# MEMORANDUM

**TO:** Richard Harris, AICP, Director of Planning, South Hadley, MA  
**FROM:** M. James Riordan, AICP, LEED AP, Senior Project Manager  
**DATE:** March 4, 2020  
**SUBJECT:** North Pole Estates Peer Review

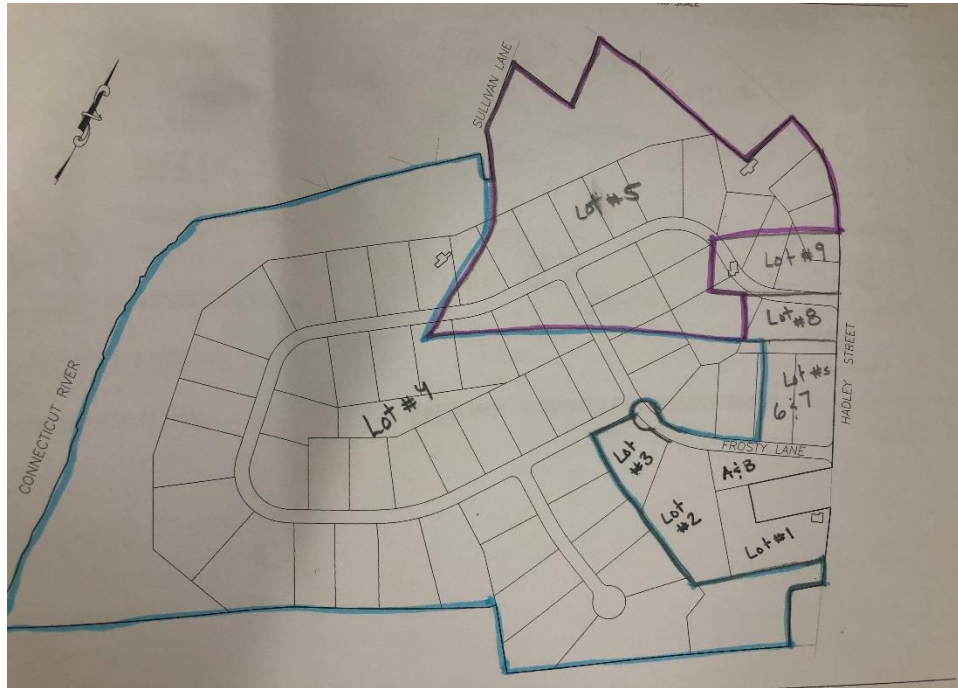
Generally, we find that the Definitive Plans were prepared in accordance with Chapter 360 of the Town's Bylaws; however, we did find inconsistency between the layout dimensions of the Preliminary Plan and the Definitive Plan. The Definitive Plans depict lots 1 through 9, with lots 4 and 5 containing the bulk of the land that would eventually be the remainder of the proposed 67 lots. Many of the lot lines shown for initial lots 1-9 do not coincide with any lot lines for future phases. See the hand-drawn graphic below:

The applicant does not provide a comparison of the lot layout that was proposed for the approved preliminary plan and the lot layout that was proposed for the proposed definitive plan, but there appear to be discrepancies. The drawing above shows the approximate location of lots lines for lots 4, 5, 8 and 9. Those lines do not appear to coincide with future development lots as depicted. This calls into question the validity of lots 4, 5, 8 and 9 as they do not seem to coincide with lot lines for future development. To address this issue, we recommend that the Town request a phasing plan from the applicant that clarifies why lots 4, 5, 8 and 9 are being created as depicted. We anticipate that future phases will require either redrawing or amendment of the lot lines. This also raises a question related to the ultimate ownership of areas in lots 4 and 5 that are not part of the depicted full-build layout. We recommend that the Town ask for a clarification of this issue.
